PWR CONTAINMENT BARRIER THRESHOLDS:

PWR CONTAINMENT BARRIER THRESHOLDS:

Figure 96-F-41: PWR Containment Integrity or Bypass Examples

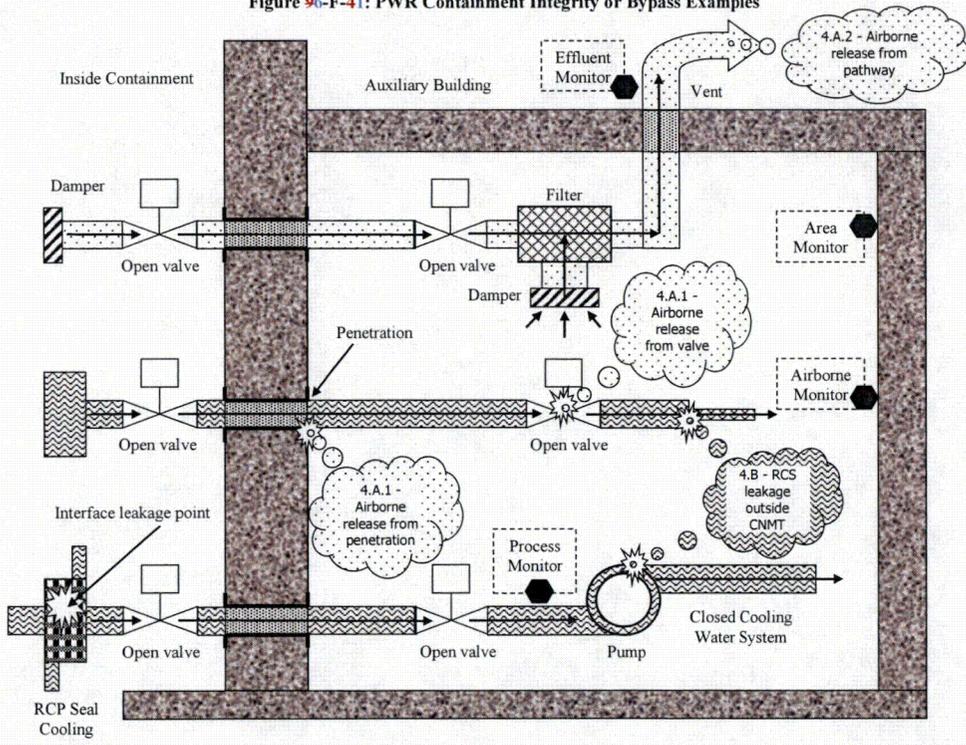
~~Refer to the~~ Two simplified examples are provided in the middle piping run of Figure 96-F-41. ~~Two simplified examples are provided.~~ One is leakage from a penetration and the other is leakage from an in-service system valve. Depending upon radiation monitor locations and sensitivities, the leakage could be detected by any of the four monitors depicted in the figure.

~~Refer to~~ See a simplified example in the top piping run of Figure 96-F-41. ~~In this simplified example,~~ the inboard and outboard isolation valves remained open after a containment isolation was required (i.e., containment isolation was not successful). There is now an UNISOLABLE pathway from the containment to the environment.

~~Refer to~~ A simplified example is shown in the bottom piping run of Figure 96-F-41. ~~In this simplified example,~~ Leakage in an RCP seal cooler is allowing radioactive material to enter the Auxiliary Building. The radioactivity would be detected by the Process Monitor. If there is no leakage from the closed water cooling system to the Auxiliary Building, then no threshold has been met. If the pump or system piping developed a leak that allowed steam/water to enter the Auxiliary Building, then threshold 4.B would be met. Depending upon radiation monitor locations and sensitivities, this leakage could be detected by any of the four monitors depicted in the figure and cause threshold 4.A.1 to be met as well.

~~Refer to~~ In the simplified example in the middle piping run of Figure 96-F-41. ~~In this simplified example,~~ a leak has occurred at a reducer on a pipe carrying reactor coolant in the Auxiliary Building. Depending upon radiation monitor locations and sensitivities, the leakage could be detected by any of the four monitors depicted in the figure and cause threshold 4.A.1 to be met as well.
